Access Compliance Report Public Rights-of-Way (Curb Ramps)

Main Street: GOSSAMER_PL Cross Street: COMET_TRAIL Location: SW

ADA ID: RPAT211101101529 Ramp Type: Type 4 - Parallel Initial Pass/Fail: Fail Overall Compliance: No Severity Score: 2

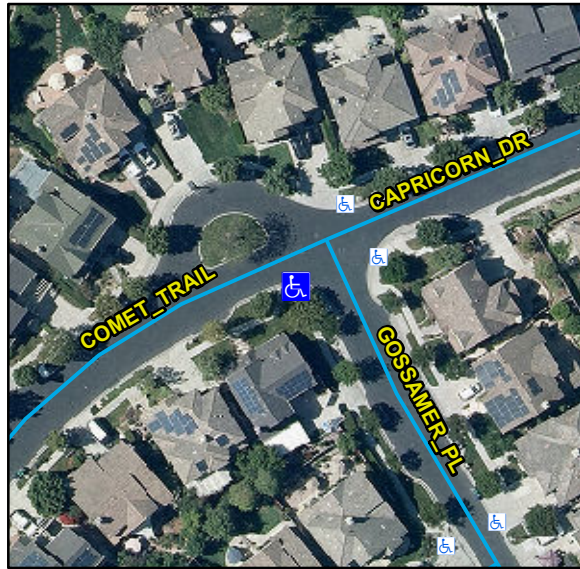
Compliance	Description	Data	Compliance	Description	Data
N/A	Ramp Length LT (in)	96	N/A	Ramp Length RT (in)	102
Yes	Ramp Width LT (in)	53	Yes	Ramp Width RT (in)	53
Yes	Ramp Run Slope LT (%)	7.3	Yes	Ramp Run Slope RT (%)	3.8
Yes	Ramp Cross Slope LT (%)	1.9	No	Ramp Cross Slope RT (%)	3
N/A	Landing Present	N/A	N/A	DWS Provided	N/A
N/A	Landing Length (in)	N/A	N/A	DWS Contrast	N/A
N/A	Landing Width (in)	N/A	N/A	DWS Length (in)	N/A
N/A	Landing Run Slope (%)	N/A	N/A	DWS Full Width	N/A
N/A	Landing Cross Slope (%)	N/A		DWS Offset Type	N/A
N/A	Landing Movement Obstructed?	N/A	N/A	DWS Offset Left (in)	N/A
	Landing Movement Type	N/A	N/A	DWS Offset Right (in)	N/A
N/A	Landing Shared	N/A			
N/A	Clear Space	Yes			
N/A	Clear Space To Crosswalk (in)	N/A			
N/A	Marked Crosswalk 1	No	N/A	Marked Crosswalk 2	No
	Crossing 1 Direction	E		Crossing 2 Direction	N
	Marked Crosswalk 1 Width (in)	N/A		Marked Crosswalk 2 Width (in)	N/A
N/A	Ramp Inside Crosswalk 1	N/A	N/A	Ramp Inside Crosswalk 2	N/A

Crossing 1 Slope (%)	2.5		Crossing 2 Slope (%)	1.7
	Crossing 1 Cross Slope (%)	0.7		Crossing 2 Cross Slope (%)	2.4
N/A	Gutter Ponding	N/A	Yes	Curb Slope	6.2
Yes	Gutter Lip Height (in)	0		Road Run Slope (%)	1.4
N/A	Gutter Run Slope (%)	N/A		Road Cross Slope (%)	2.6
N/A	Gutter Cross Slope (%)	N/A	No	Perpendicular Joint Present	No
Yes	Overall Surface Condition	Acceptable			
	Cross Gutter Present?	No		Spandrel Present?	No
	Replace Cross Gutter?	N/A		Replace Spandrel?	N/A

Remove & Replace Curb Ramp With Two New Directional Ramps or Equivalent.

R204.3, R304.5.3, STD 1115
